AGENDA
CITY OF LAKE WORTH BEACH
HISTORIC RESOURCES PRESERVATION BOARD REGULAR MEETING
VIA TELECONFERENCE
WEDNESDAY, OCTOBER 14, 2020 -- 6:00 PM

**MINUTES
CITY OF LAKE WORTH BEACH
HISTORIC RESOURCES PRESERVATION BOARD REGULAR MEETING
BY TELECONFERENCE
WEDNESDAY, SEPTEMBER 09, 2020 -- 6:00 PM**

31 South Golfview Road
Original Roller Awning Shutters

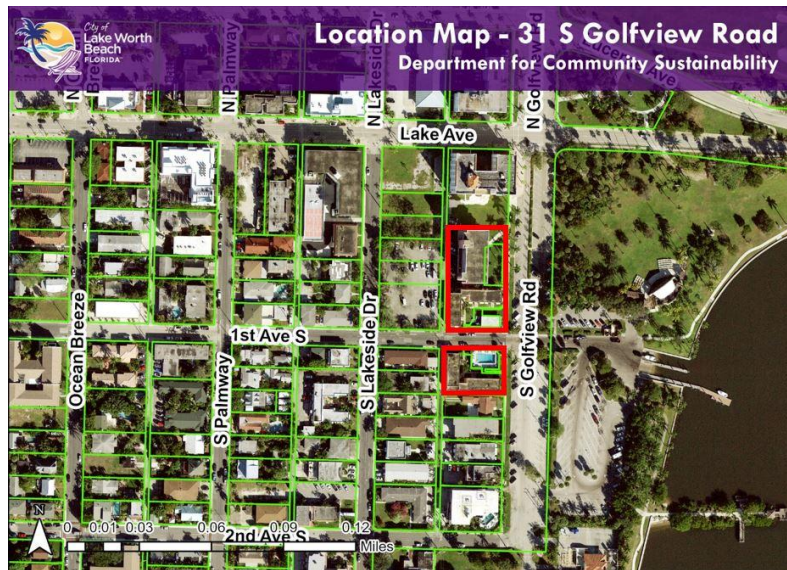
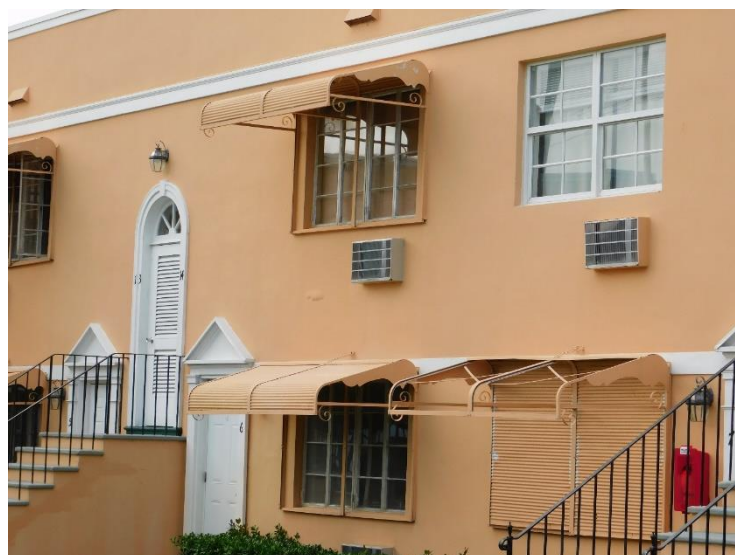
The proposed project is not consistent with Goal 1.4 of the Comprehensive Plan, which encourages preservation and rehabilitation of historic resources, since accordion shutters are very intrusive and cannot be stored out of sight when not in use. The proposed project is also not in compliance with Policy 3.4.2.1 requires that properties of special value for historic, architectural, cultural, or aesthetic reasons be restored and preserved through the enforcement of the City’s Historic Preservation Ordinance to the extent feasible. Per the City’s Historic Preservation Ordinance (LDR Sec. 23.5-4), the Lake Worth Beach Historic Preservation Design Guidelines, and the Secretary of Interior Standards for Rehabilitation, exterior alterations should be substantiated by documentary, physical, or pictorial evidence. The proposed accordion shutters are not appropriate and do not replicate the original roller awning shuttering system utilized in the structure.

Staff Analysis: The proposed installation of Bertha aluminum impact accordion shutters in white over the existing openings on unit #13 will result in a substantial change to the structure's appearance. Accordion shutters utilize permanent tracks and cannot be stored out of sight when not in use. This will have a negative visual impact on the structure, as all units are unlikely to utilize the same shuttering system.

The proposed installation of Bertha aluminum impact accordion shutters in white over the existing openings on unit #13 will result in a substantial change to the structure's appearance. As the request is not in compliance with the Lake Worth Beach Historic Preservation Design Guidelines criteria for shuttering systems for historic structures, Staff is not recommending approval of the application as submitted. The HRPB, as tasked in the LDR Sec. 23.2-7(C)(7), shall review the request and supporting exhibits to determine if a Certificate of Appropriateness for the accordion shutter installation for the contributing resource may be granted.

West Elevation (Fronting North L Street)

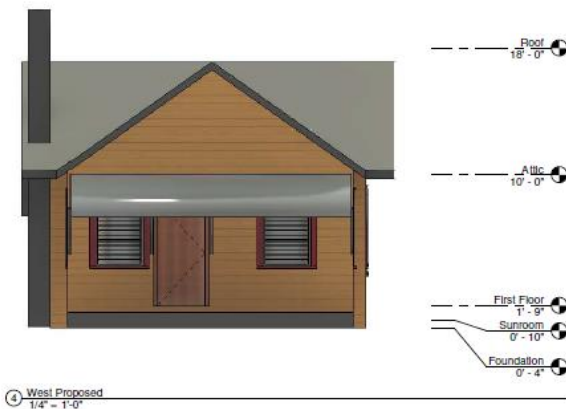
There are no proposed changes or replacement windows on the front façade. With the exception of the front door that will be replaced with a Stevens & Sons fiberglass impact door with a 6-light divided-light pattern. Per the Lake Worth Beach Historic Preservation Design Guidelines, the proposed door is visually compatible with the Wood Frame Vernacular structure.

Proposed Front Door

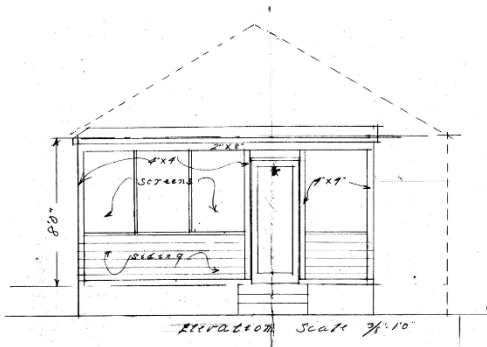
Staff Analysis: The proposed window and door replacement with PGT aluminum impact single-hung and fixed windows, and a Steven & Sons fiberglass impact front door and a pair of PGT aluminum impact French doors will result in a substantial change to the structure's appearance. Although an improvement from the existing replacement windows, the proposed window replacement does not *successfully* replicate the original windows in a manner that compliments the architectural significance of the structure.

Architecturally Compatible Alternative

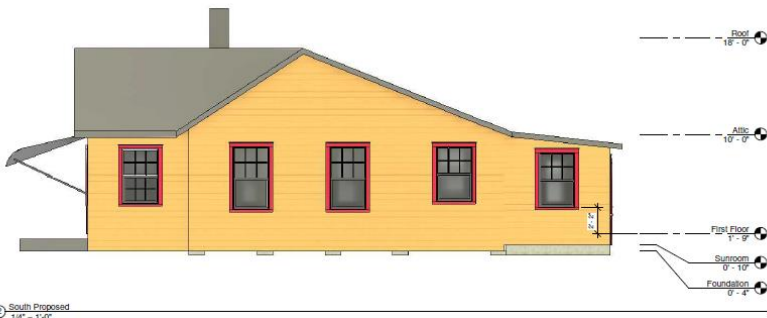
Based upon the existing original opening sizes, the replacement jalousie windows should be replaced with single-hung and casement windows as illustrated in the Wood-Frame Vernacular style section of the Lake Worth Beach Historic Preservation Design Guidelines, depicted below. Original openings sizes should not be enclosed or altered. Staff has included Conditions of Approval to allow the Applicant to replace the existing windows and doors in the existing openings in accordance with the Lake Worth Beach Historic Preservation Design Guidelines requirements on window and door replacement for historic structures.

There are several options for compatible alternatives. Retaining the greatest number of original openings is recommended. However, if new opening sizes are desired Staff recommends utilizing the dimensions of original openings. The structure has original openings that likely accommodated hung and casement windows that can be replicated in size and appearance.

Most Successful Replacement

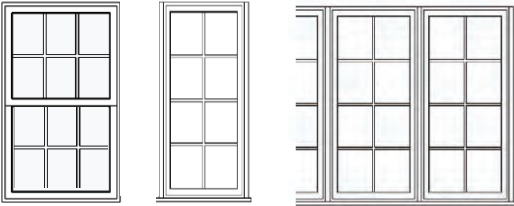
Rear openings with a jalousie windows will be removed. Four (4) openings will be reconfigured to accommodate PGT aluminum impact single-hung windows. In addition, the original wood-hung window will remain in the front enclosed porch.

Based upon the existing original opening sizes, the replacement jalousie windows should be replaced with single-hung and casement windows as illustrated in the Wood-Frame Vernacular style section of the Lake Worth Beach Historic Preservation Design Guidelines, depicted below. Original openings should not be enclosed or altered. Staff has included Conditions of Approval to allow the Applicant to replace the existing windows and doors in the existing openings in accordance with the Lake Worth Beach Historic Preservation Design Guidelines requirements on window and door replacement for historic structures.
